Attachment 3 (reference: Question #1)

**General License Document  
Amendment to Operations Manual**

This letter is in response to your application dated September 20, 1995, requesting to amend the registration for the Model MK 1.0 transmission gauge. We are in the process of performing a safety evaluation for the device. However, in order to continue our evaluation, the following information is necessary:

Geräteart	26.07.1994	Seite	1/1
Gerät	1.1.1	Seite	1/1
Modell	Aufbauplan Strahlerabschirmung Sr 90		
11	Construction plan of source shielding		
	Plan de construction du blindage de source

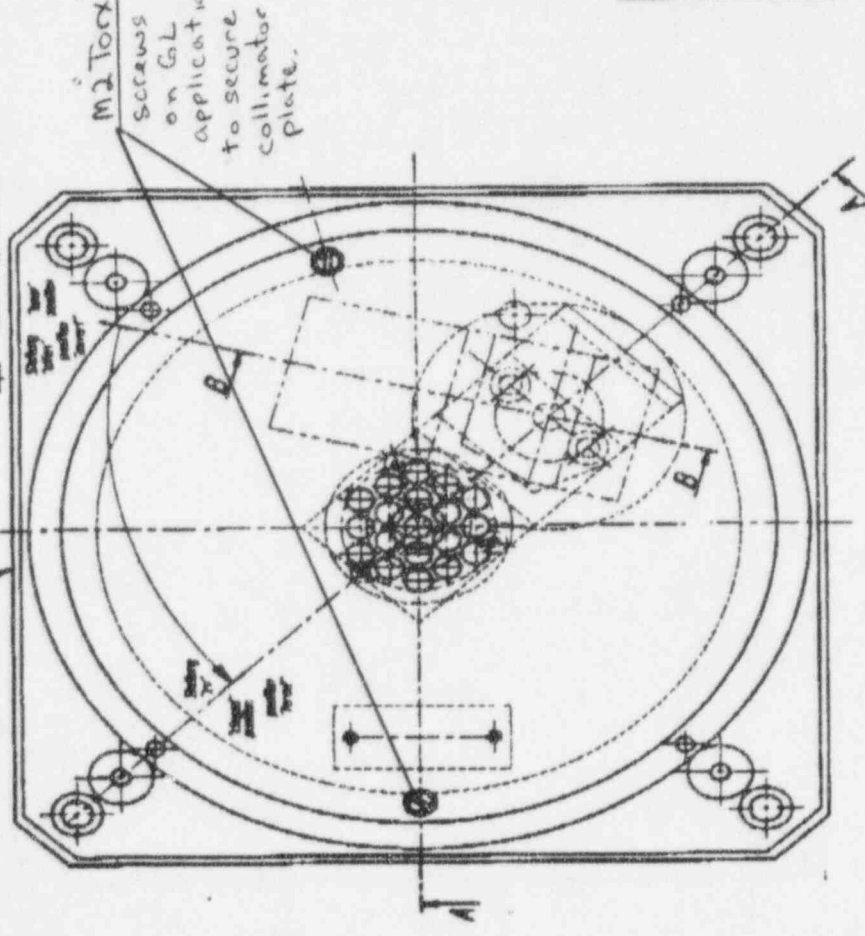
2. Betacontrol's application and your letter dated May 1, 1996, indicate that there are no design differences between the device intended for use under a specific license and the ones intended for use under a general license. In order to distribute the device to GL users, you must demonstrate that the device design restricts user access to the source. The information that we have on file indicates the use of ordinary fasteners. Restricted access to the source is commonly accomplished through the use of tamper-resistant screws, rivets, or welds. In addition, if a design change is necessary, the quality assurance/quality control procedures submitted in your May 1, 1996, letter should be amended to check for these design changes on new devices being sent to GL users and ones being changed from use by SL users to use by GL users.

M2 Torx  
screws  
on G.L.  
application  
to secure  
collimator  
plate.
